CERTIFICATE OF APPROPRIATENESS

Applicant: Israel Valles, agent for Robert W. Drummond, owner

- Property:721 Columbia Street, Lot 7, Block 257, Houston Heights Neighborhood
Subdivision. The property includes a historic 2,589 square foot, one-story wood
single-family residence and attached carport situated on a 6,600 square foot (132'
x 50') interior lot.
- **Significance:** Contributing Craftsman Bungalow style residence, constructed circa 1920, located in the Houston Heights South Historic District.
 - **Proposal:** Alteration Addition, windows, porch

SOUTH (LEFT) ELEVATION - CARPORT SIDE

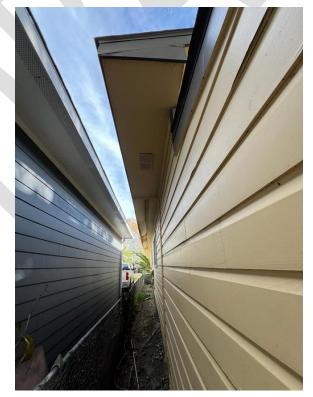
Carport and non-historic side addition has since been removed.
